**GS# 104-215 Jones Hall Interior Renovations
Mississippi University for Women**

Addendum No. 3

SHEET **E301**

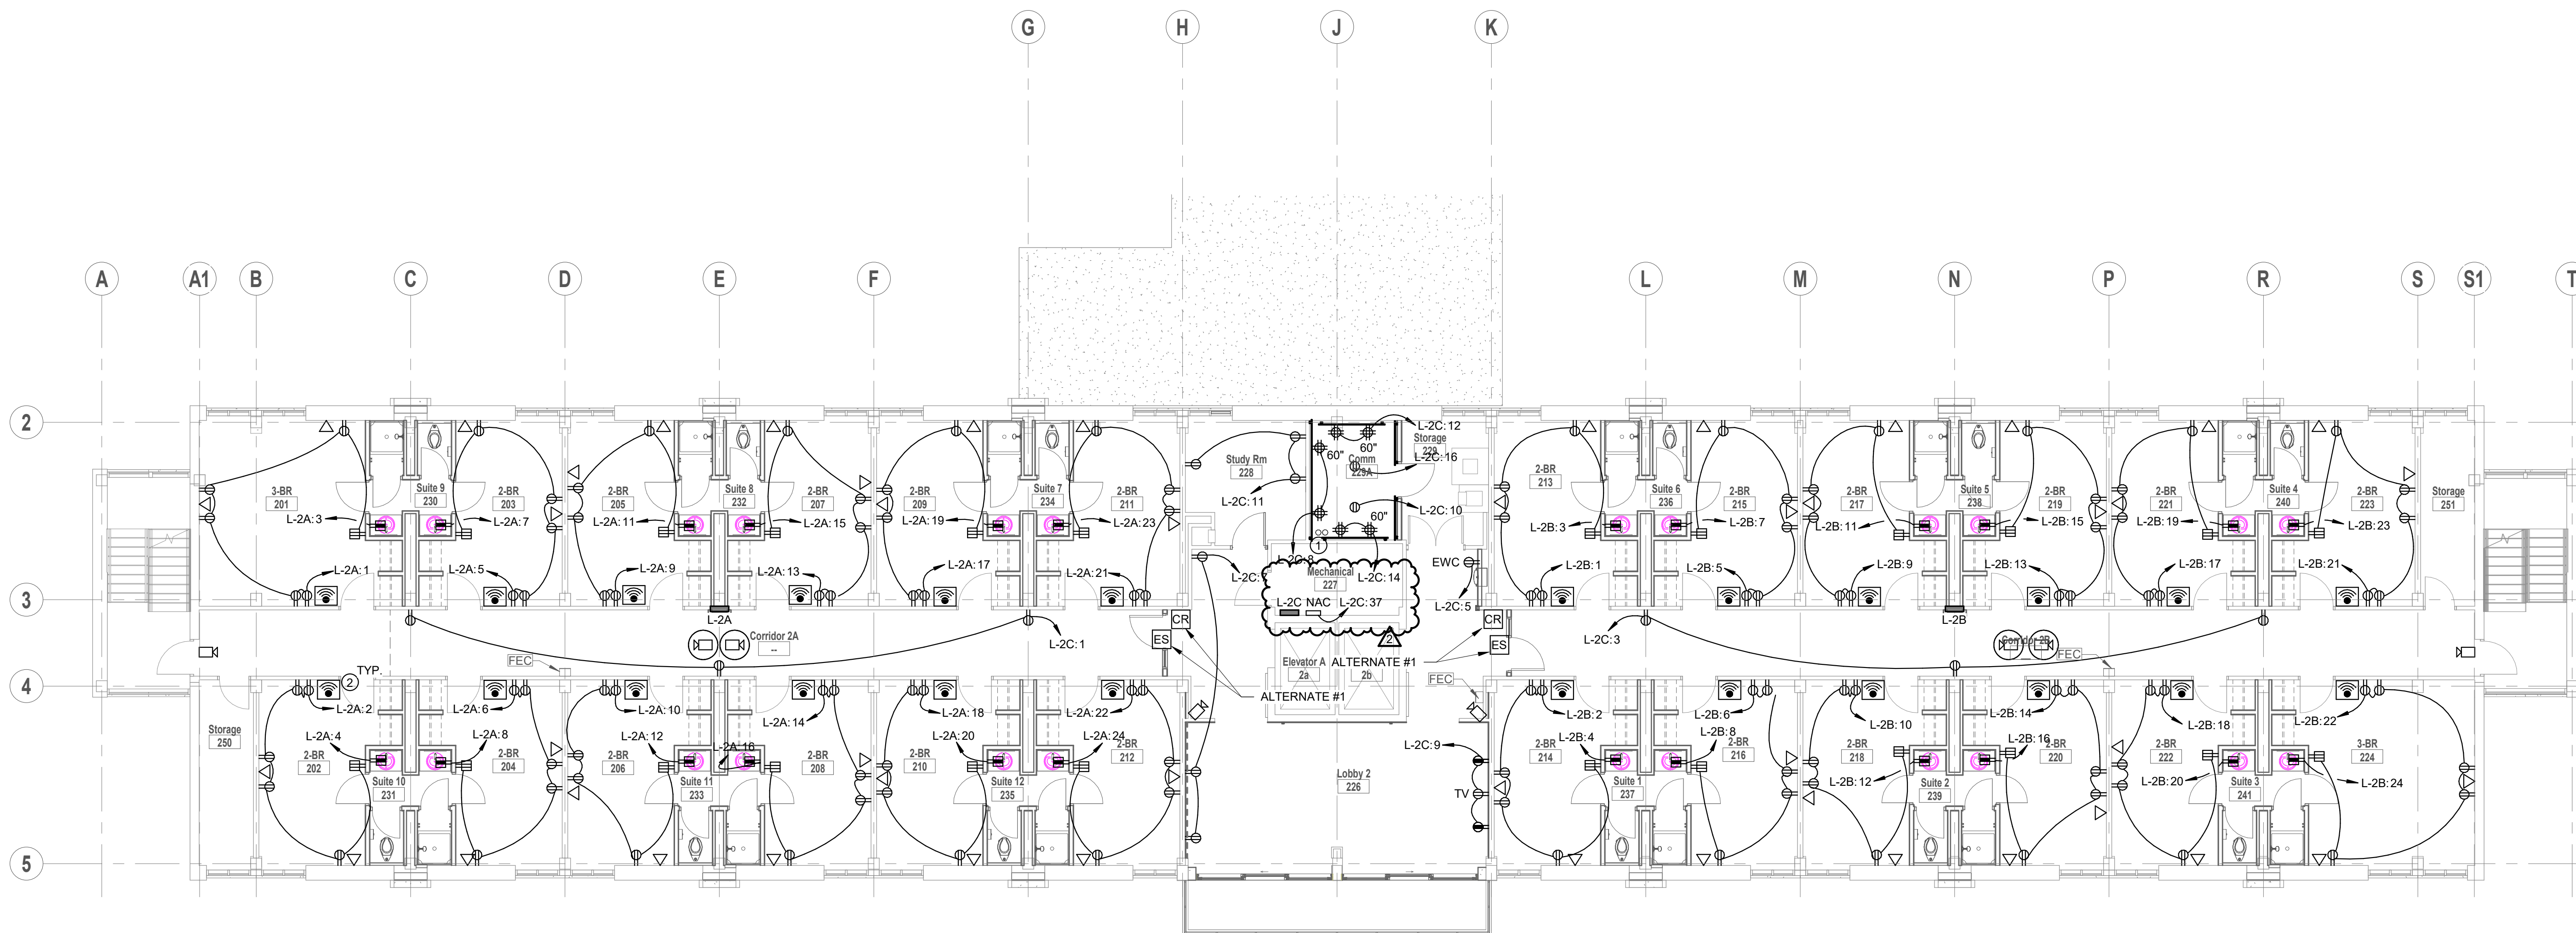
- l. Revise Sheet E301 and replace with attached Sheet E301. Revisions included adding disconnects and sheet keynotes for both elevator cab lights and elevator exhaust fan. The existing elevator disconnects have now been removed and replaced with new and the keynotes are updated to reflect the changes. Added keynote “I” to cover the auxiliary systems responsibilities. Added GFCI receptacles to the elevator shaft and elevator machine room.

- NEW CONSTRUCTION NOTES:**
- 1 REPLACE AND REFEED DISCONNECT SERVING ELEVATOR A AND PROVIDE NEW AUXILIARY CONTACTS. CIRCUIT AS SHOWN ON THE RISER DIAGRAM.

SHEET **E302**

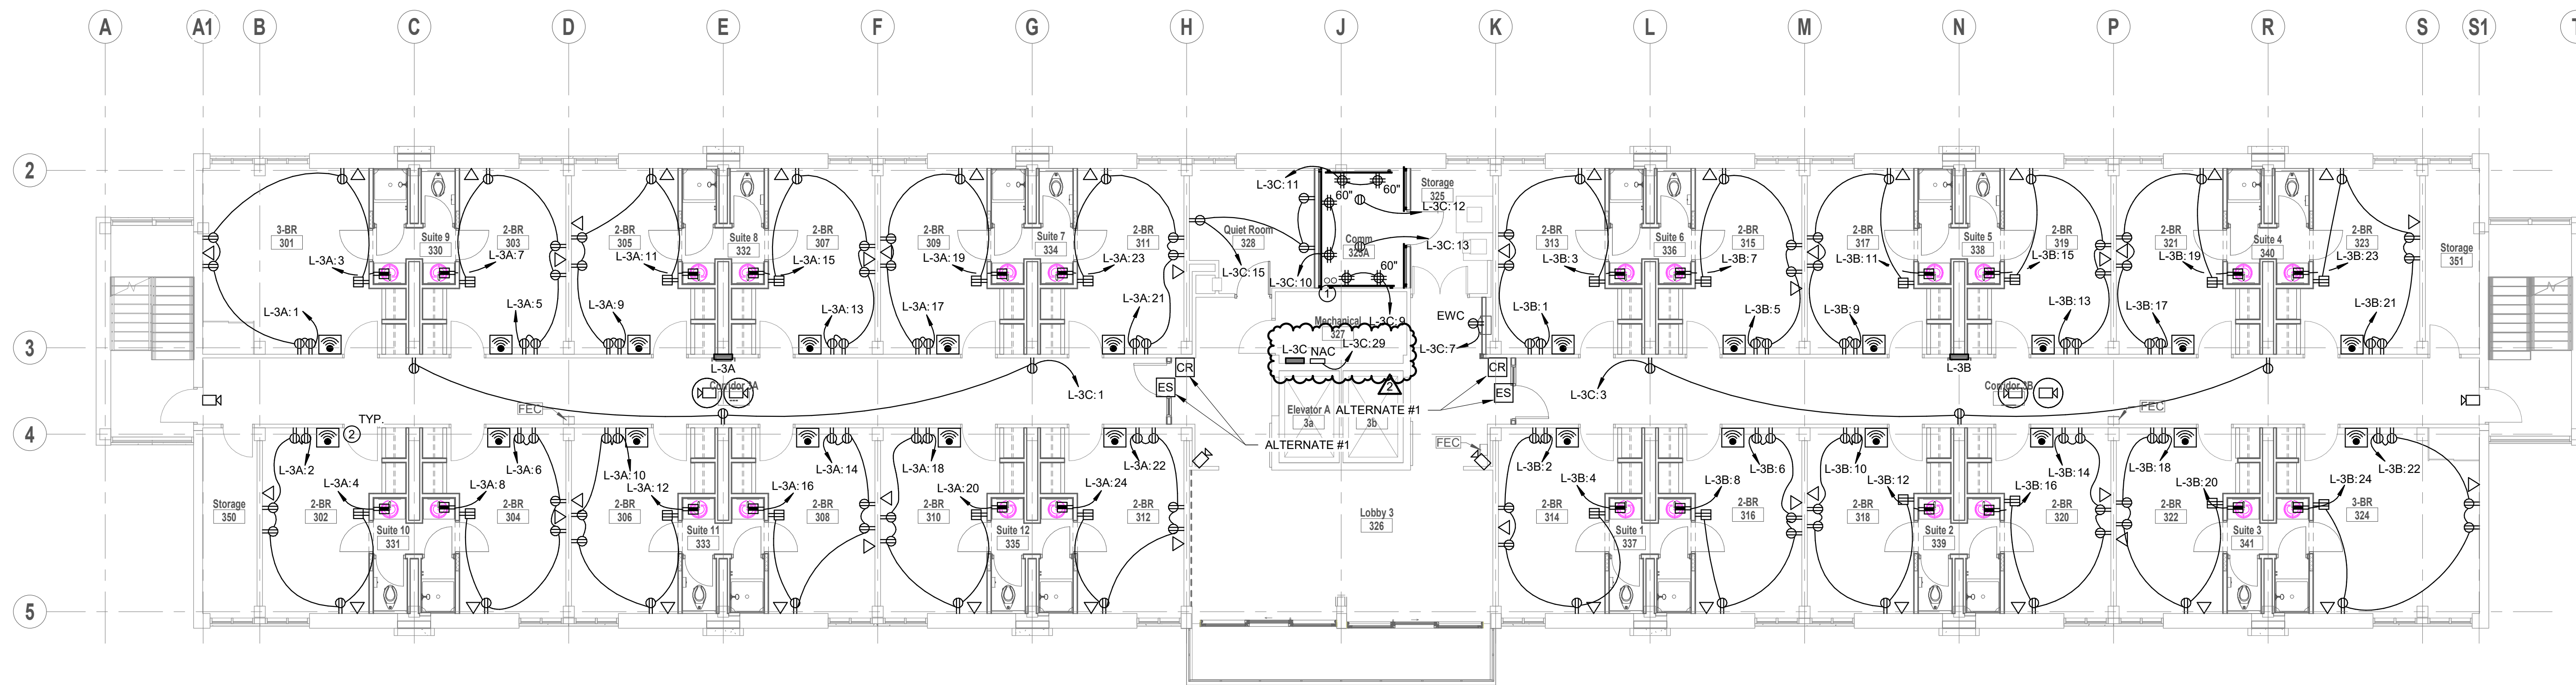
- m. Revise Sheet E302 and replace with attached Sheet E302. Revisions include adding NAC fire alarm panel to mechanical room.
- n. Revise Sheet E303 and replace with attached Sheet E303. Revisions include adding NAC fire alarm panel to mechanical room.

SHEET **E305**

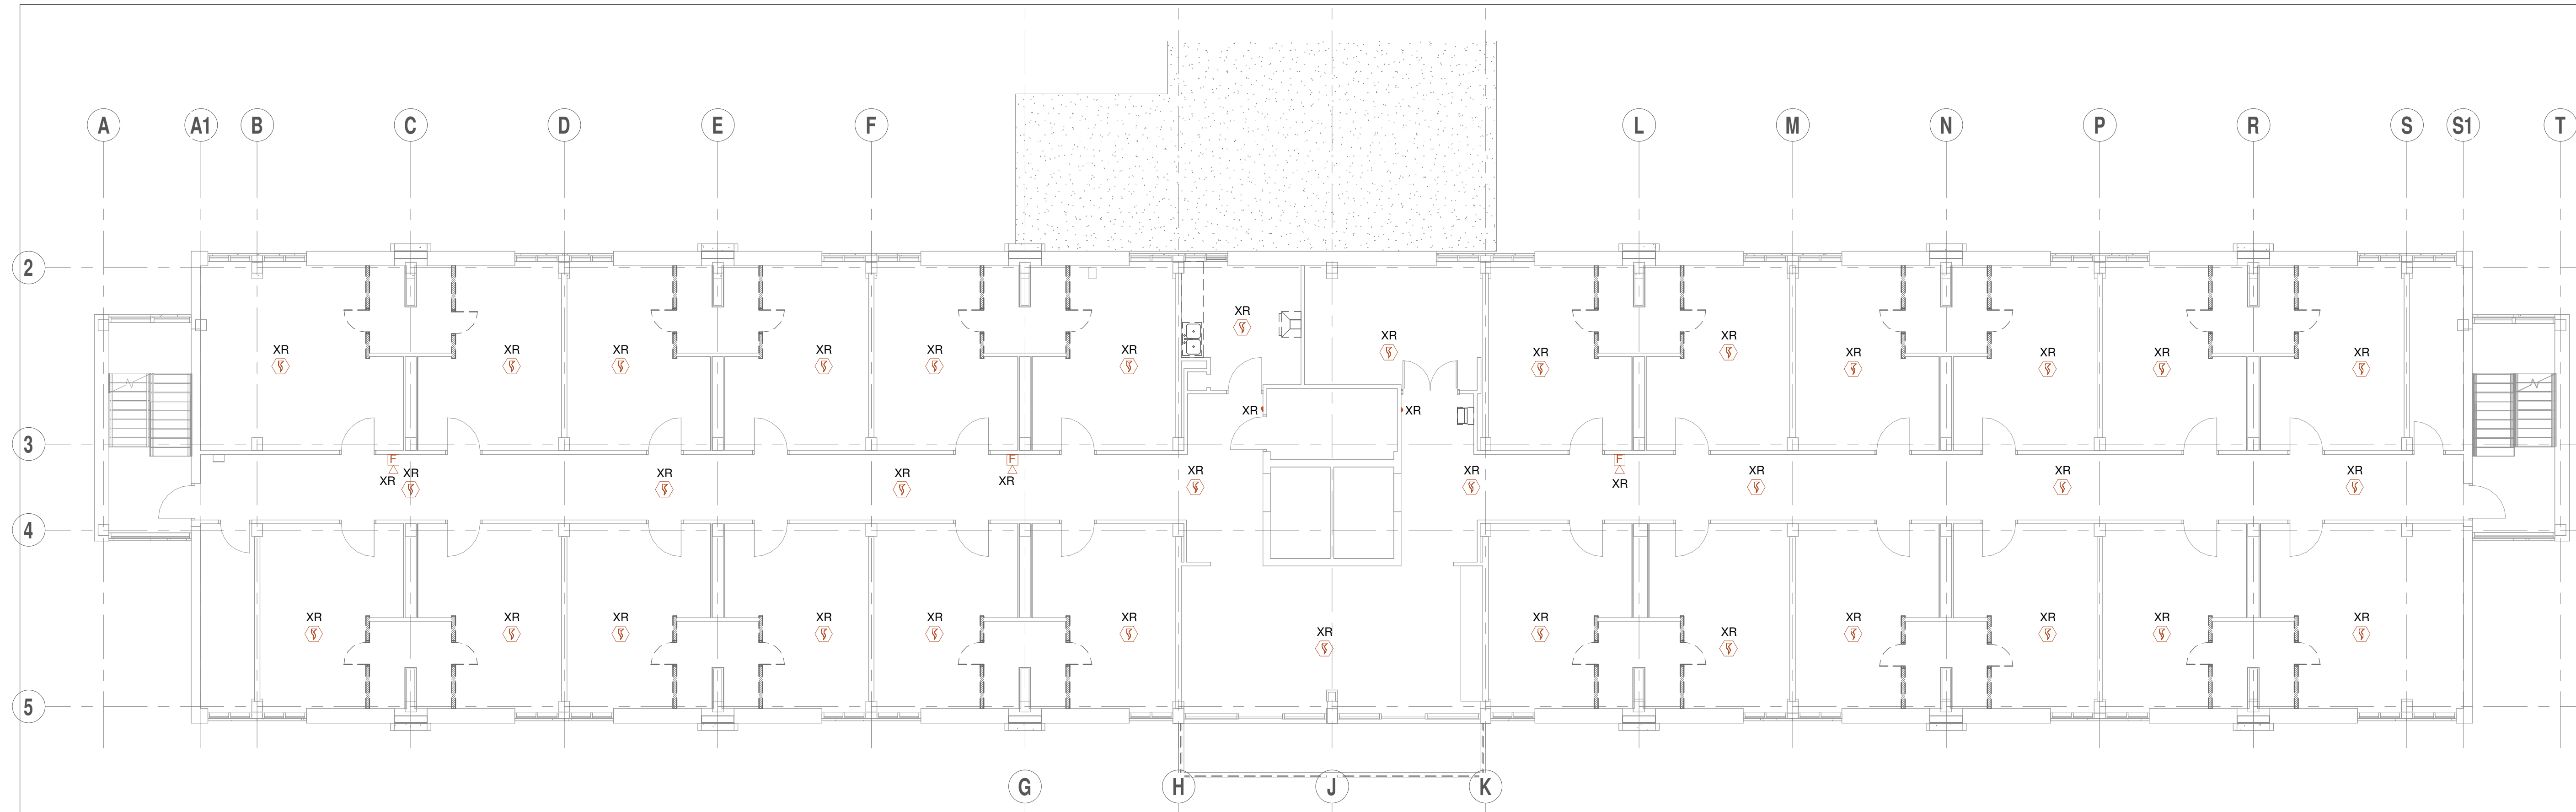
- o. Revise Sheet E304 and replace with attached Sheet E304. Revisions include adding NAC fire alarm panel to mechanical room.
- p. Revise Sheet E305 and replace with attached Sheet E305. Revisions include adding NAC fire alarm panel to mechanical room.

SHEET **E402**

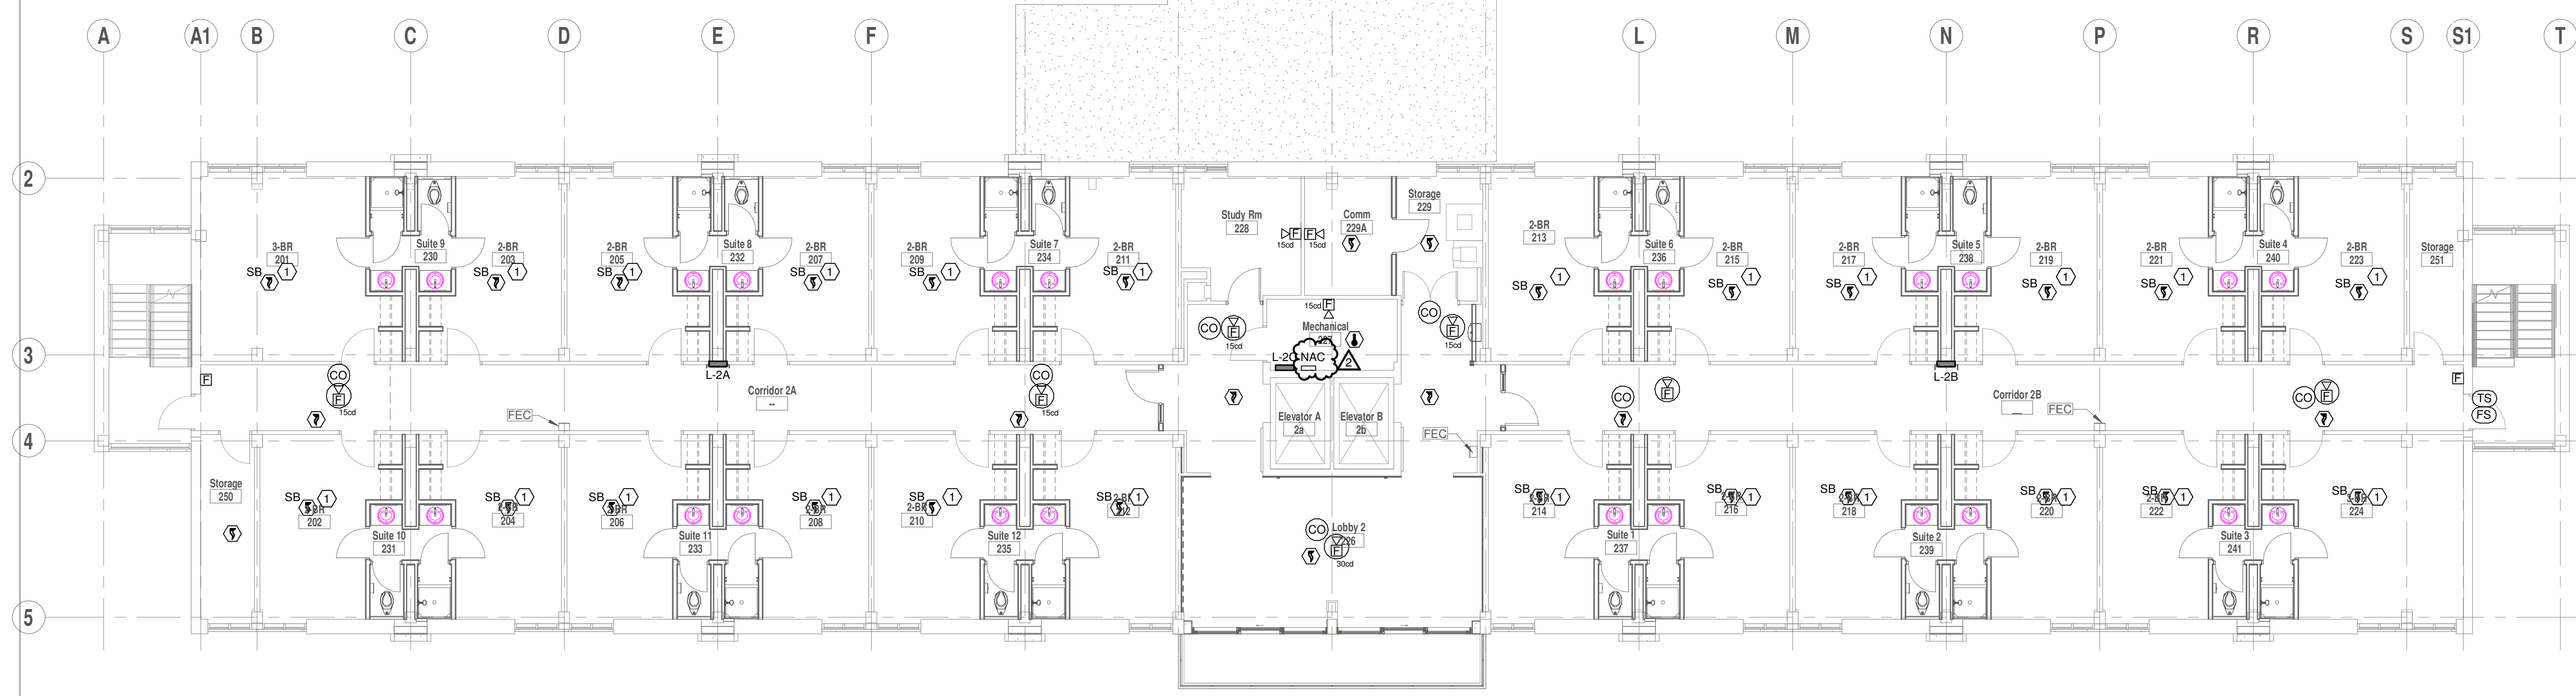
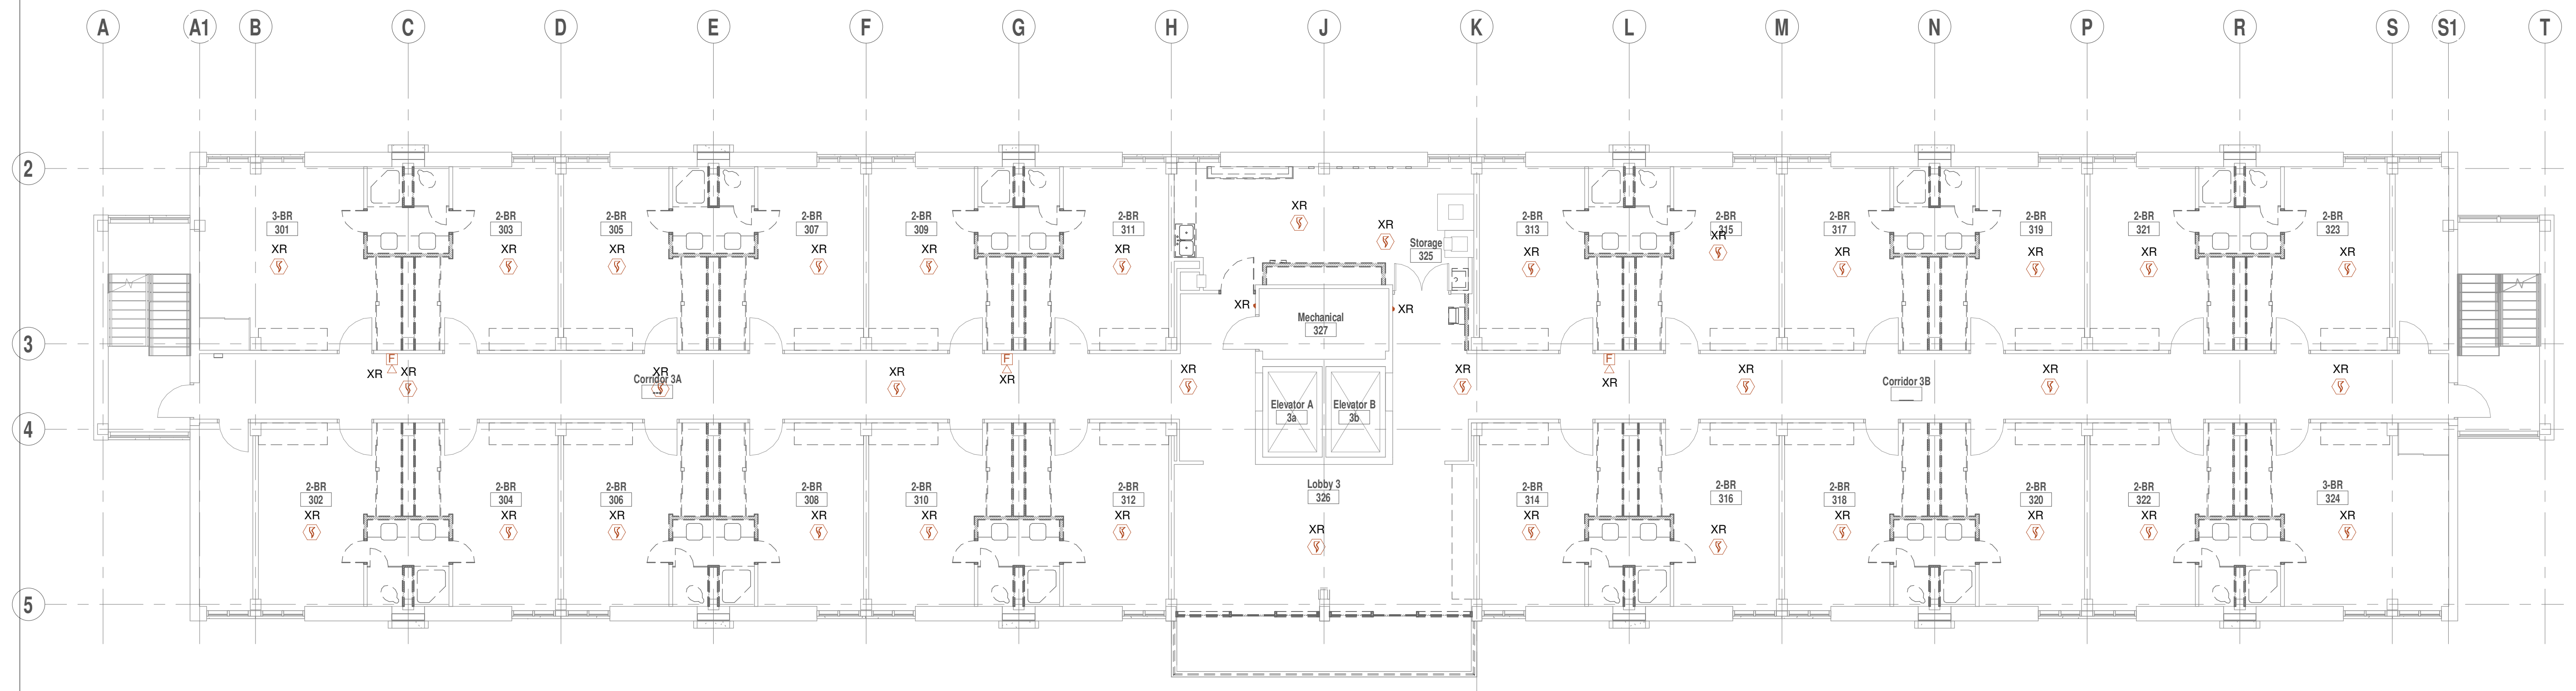
- q. Revise Sheet E402 and replace with attached Sheet E402. Revisions include adding NAC fire alarm panel to mechanical room.
- r. Revise Sheet E403 and replace with attached Sheet E403. Revisions include adding NAC fire alarm panel to mechanical room.
